LA MESA-SPRING VALLEY SCHOOL DISTRICT

BID NUMBER FB #25/26-002
DISTRICTWIDE PLUMBING
UPGRADES PROJECT- PHASE 2

THIS ADDENDUM IS ISSUED AS ADDITIONAL INFORMATION AND/OR AS A CHANGE IN SPECIFICATIONS
OR INSTRUCTIONS TO ALL PROSPECTIVE BIDDERS INTERESTED IN THE ABOVE-MENTIONED BID .

Maryland Avenue Elementary - 5400 Maryland Ave, La Mesa, CA 91942, Spring Valley, CA 91977

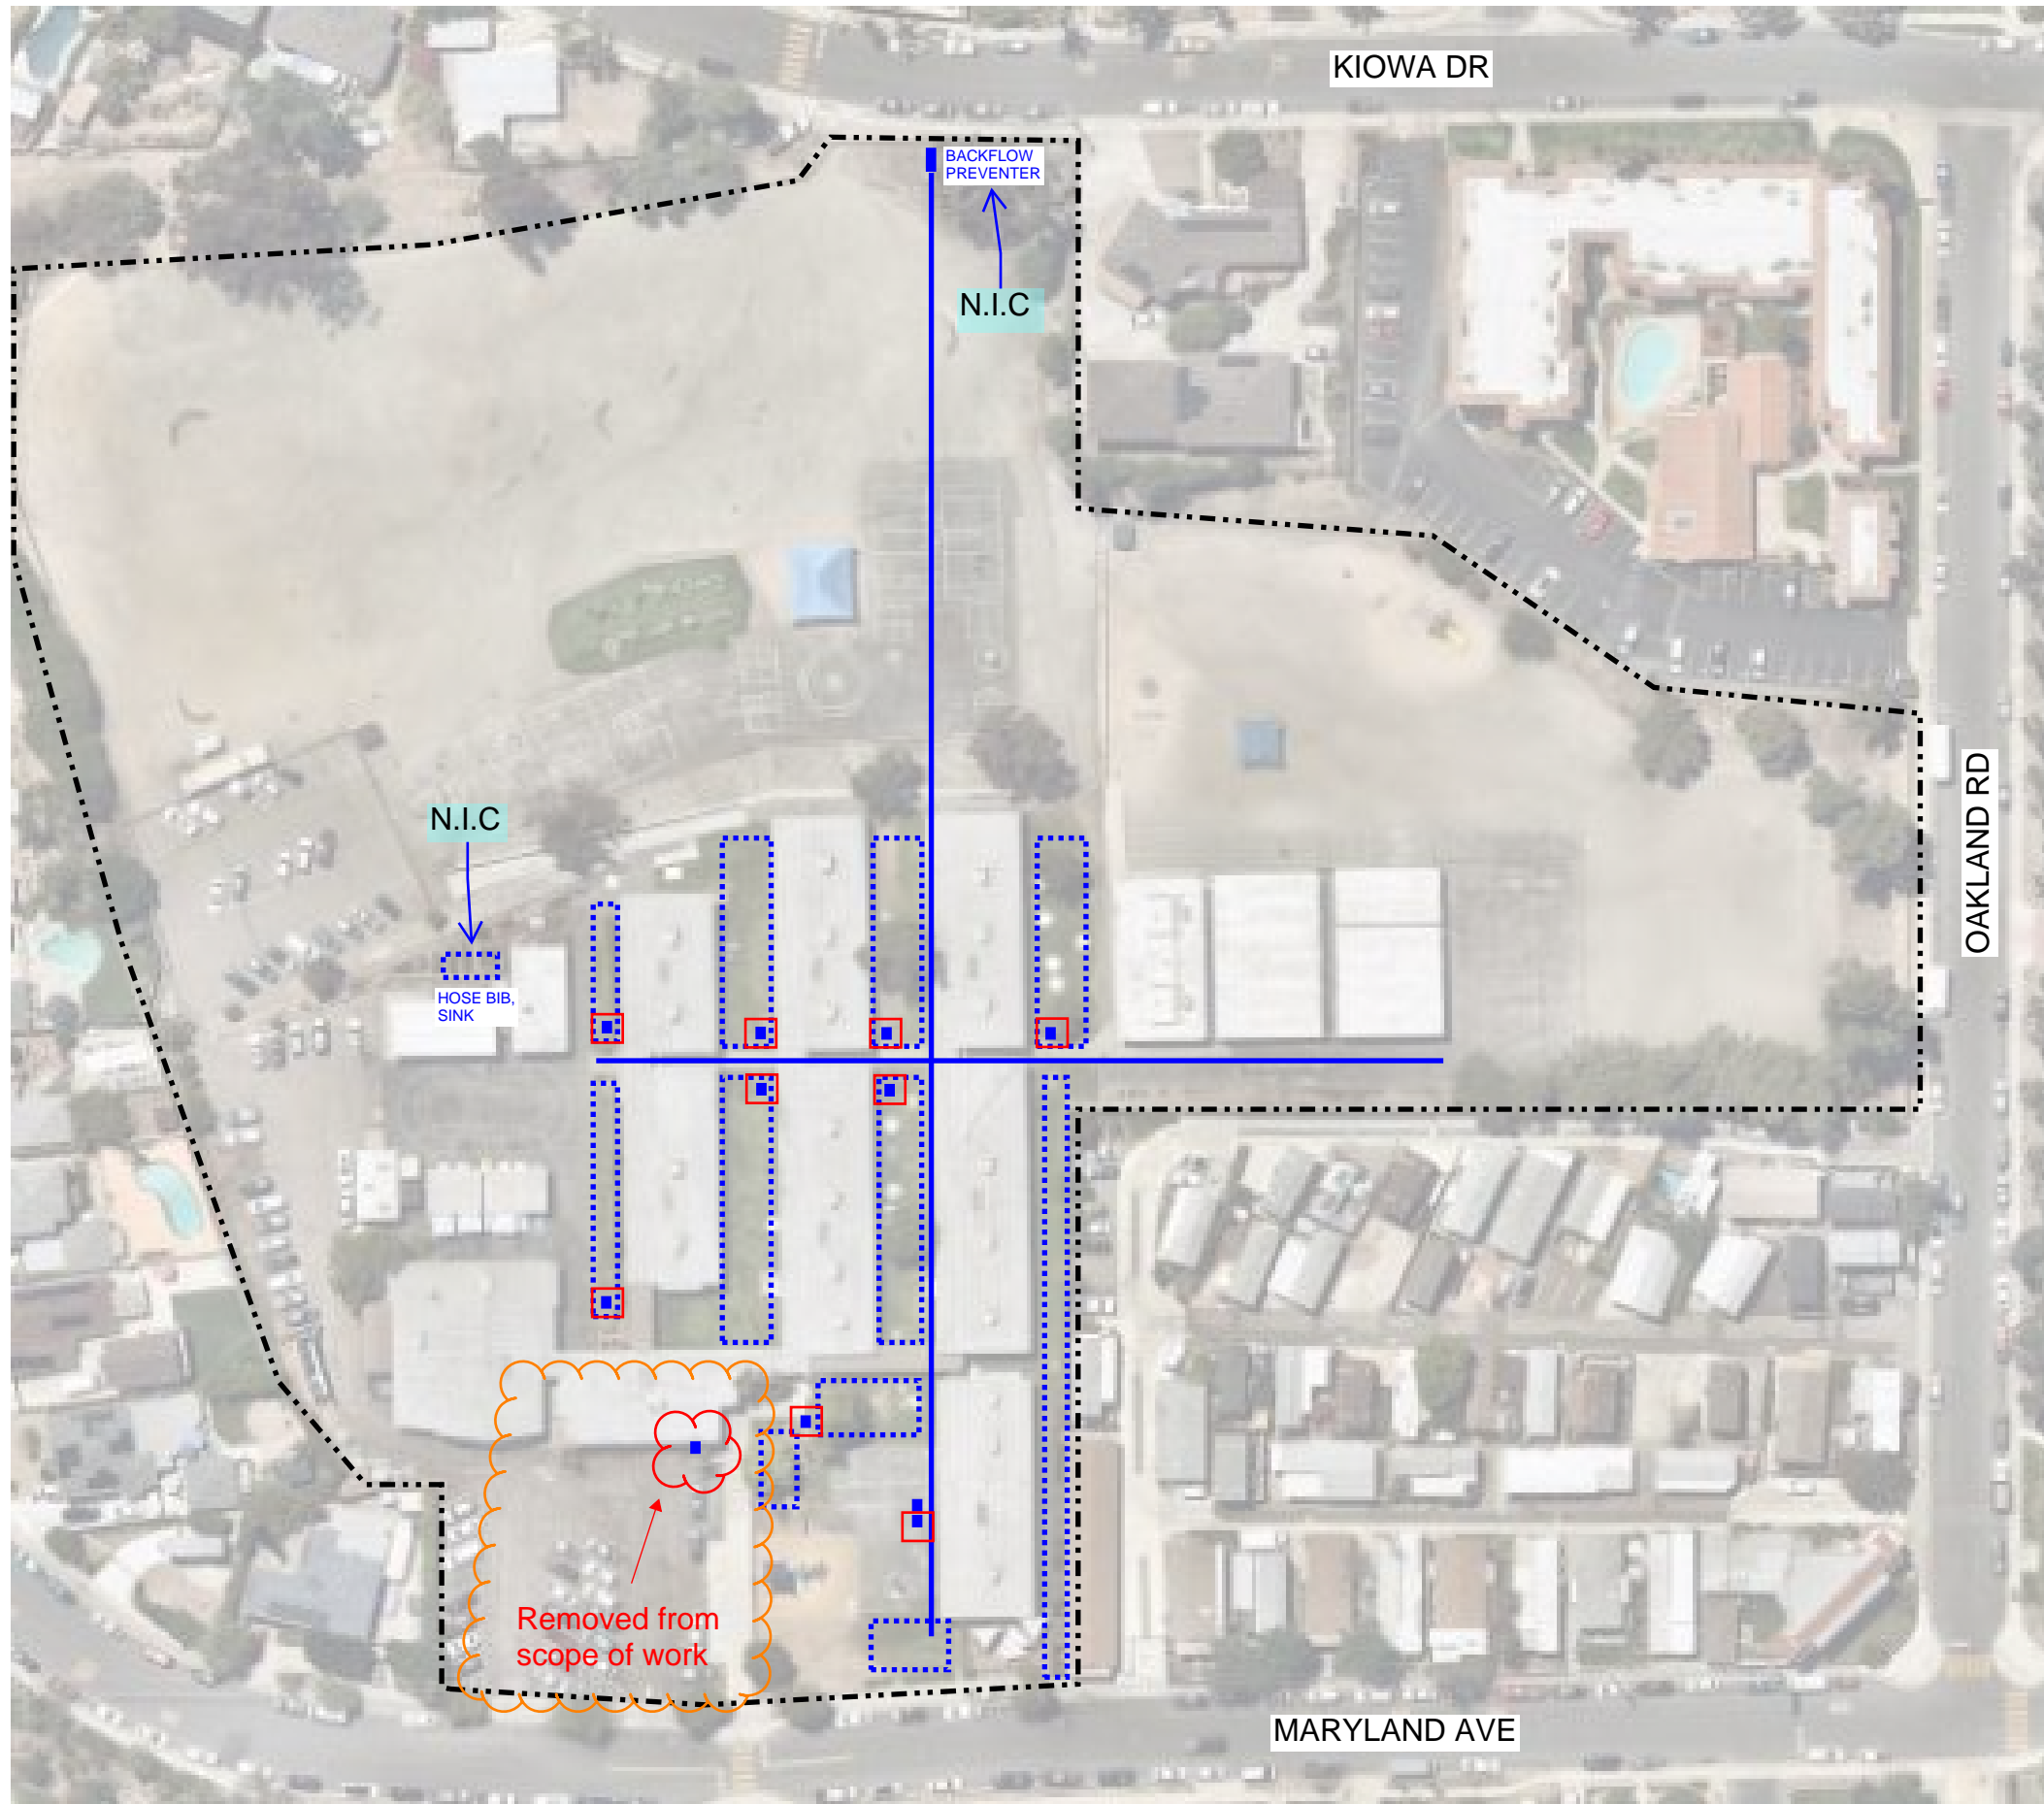
Revised 04.28.2026

NOTES:
1. One existing BFP.

(9) New back flow, cages and concrete pad locations. Back flows must be certified after installation
